## Product Change Notification / SYST-21MVID450

ERRATA - dsPIC33EVXXXGM00X/10X Family Silicon Errata and Data Sheet Clarification Document Revision

- 1) Updates silicon issues 6 (Input Capture) and 25 (Comparator).
- 2) Adds data sheet clarifications 2 (Interrupt Controller), 3 (Oscillator Configuration), 4 (Charge Time Measurement Unit (CTMU)) and 5 (Packaging Information).

## dsPIC33EVXXXGM00X/10X Family Silicon Errata and Data Sheet Clarification

### 64-Lead Plastic Quad Flat, No Lead Package (MR) – 9x9x0.9 mm Body with 5.40 x 5.40 Exposed Pad [QFN]

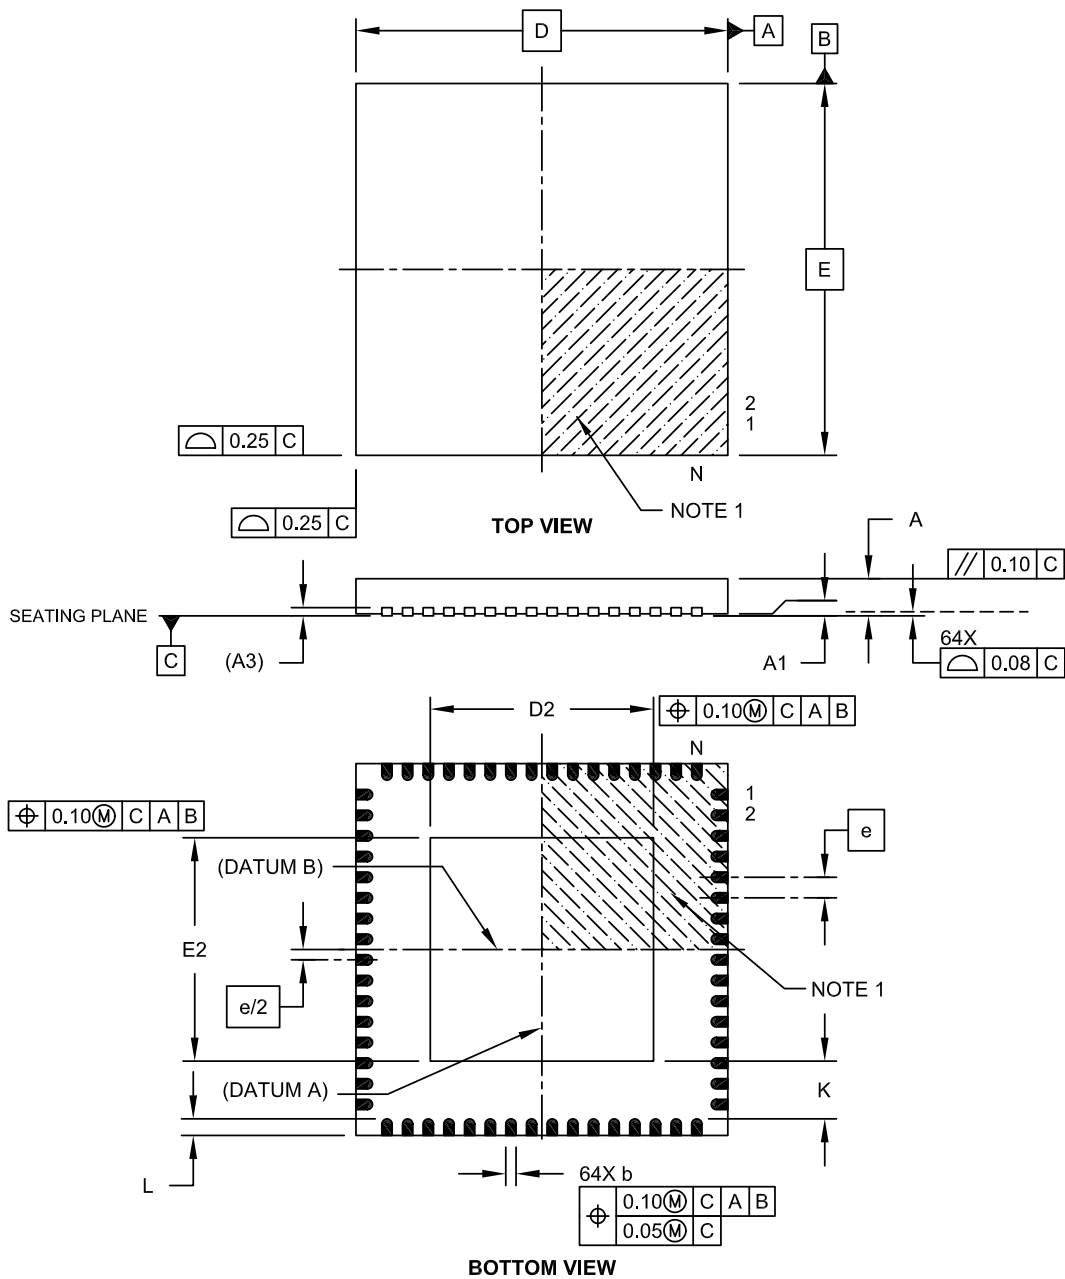
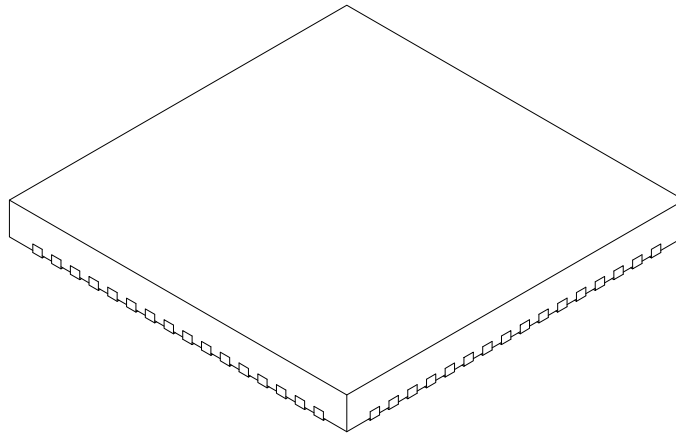
The package drawing for the 64-pin QFN device has been updated with the 64-Lead Plastic Quad Flat, No Lead package (MR) – 9x9x0.9 mm Body with 5.40x5.40 Exposed Pad [QFN] package drawing as shown below.
